**SHEARON HARRIS NUCLEAR POWER PLANT, UNITS 2 AND 3  
DOCKET NOS. 52-022 AND 52-023  
RESPONSE TO REQUEST FOR ADDITIONAL INFORMATION LETTER NO. 020 RELATED TO  
STABILITY OF SUBSURFACE MATERIALS AND FOUNDATIONS**

**Shearon Harris Nuclear Power Plant Units 2 and 3  
Response to NRC Request for Additional Information Letter No. 020 Related to  
SRP Section 02.05.04 for the Combined License Application, dated September 26, 2008**

**NCR Letter No.: HAR-NRC-LTR-020**

Figure A-1  
Comparison of Suspension Logging  $V_s$  Data Results in 10-Ft Elevation Ranges  
Below El. 220 Ft - HAR 3

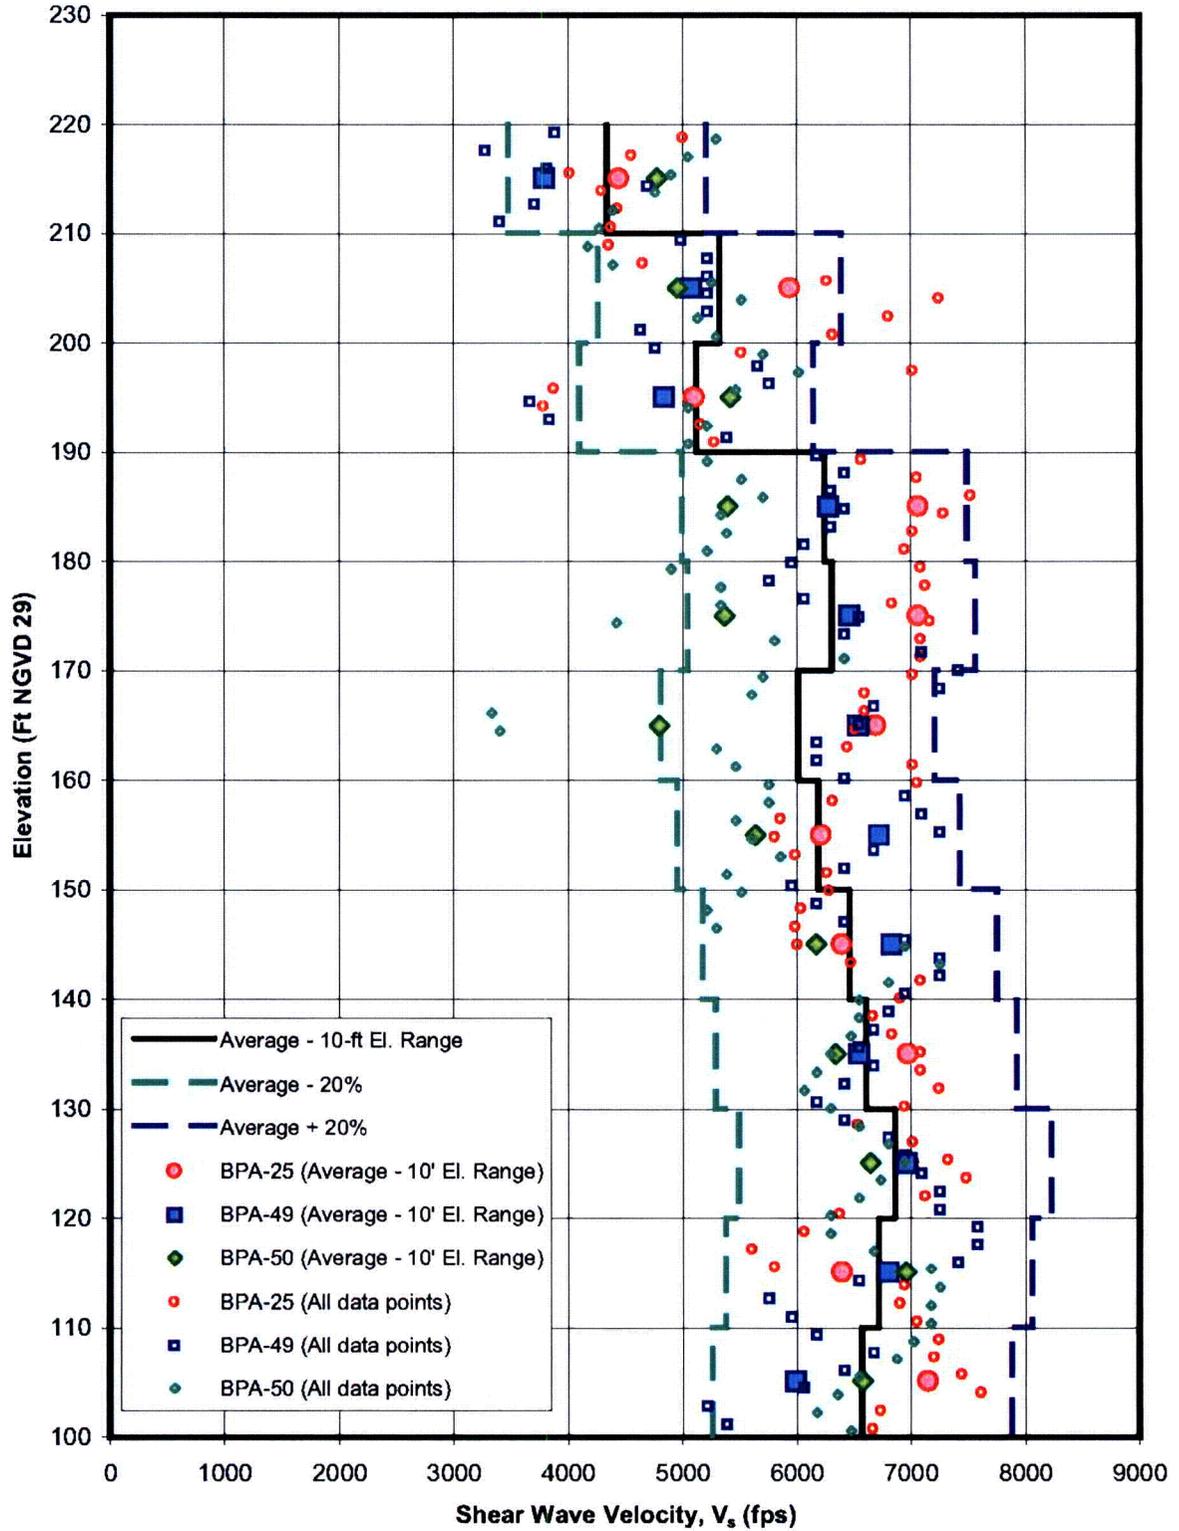
FSAR Section 2.5.4.4.2.1.1, "HAR 2" states "For dip-correlated strata below the nuclear island subgrade elevation of 67.1m (220 ft) amsl,  $V_s$  measured in the boreholes fall within 20 percent of the average among the three holes, except at a few isolated intervals (Figure 2.5.4-214B). The exceptions typically span only one or two suspension logging data points, representing up to approximately 1 m (3ft.) in thickness." This appears to be true except for immediately under the HAR 3 basemat. Referencing the HAR 3 shear wave velocity profiles, it is observed that the measured shear wave velocities between El. 210 and El. 220 vary from approximately 3500 fps in BPA-49 to 5100 fps in BPA-50. While the average of the 3 shear wave velocities in the subject depth interval within or in close proximity to the NI footprint would approximately be within the plus or minus 20% criteria, the data also seem to indicate a softening of the rock on the Northeast side of the HAR 3. The lower average value of 3500 fps observed in Boring BPA-49 is 30% lower than the average value of 5100 fps observed for the same depth interval at boring BPA-50.

Please clarify how it was determined that the variation observed at HAR 3 between El. 210 and El. 220 is within the criteria for a uniform site, and does not require additional site investigations on closer spacing.

In addition to the consistency of dip-related rock layers within the HAR 3 footprint, there is also general consistency of  $V_s$  between boreholes at equal-elevation ranges, without adjustment for dip. To demonstrate this, the average of suspension logging  $V_s$  measurements in the each of the three HAR 3 boreholes were calculated for each 10-foot elevation interval between elevation 220 and 100 feet. The overall average  $V_s$  value for all values in the three boreholes was also calculated for each elevation range. Figure A-1 (see page 7) shows the overall interval average  $V_s$ , the individual borehole average  $V_s$ , the  $V_s$  values that bracket 20 percent above and below the overall average, and the individual  $V_s$  data points.

As shown on Figure A-1, the 10-foot elevation interval averages in each borehole are bound within 20 percent of the overall average for the interval in nearly every case, including elevation 210 to 220 feet. The only exception is at elevation 160 to 170 feet, where the BPA-50 borehole average is 20.2 percent below the mean. This exception is driven by the presence of the clay seam discussed in section A above. Presence of such thin low- $V_s$  intervals was considered in the site response analyses presented in FSAR 2.5.2. Therefore, the AP1000 DCD site uniformity criteria for  $V_s$  variation are effectively satisfied even without consideration of bedding dip.
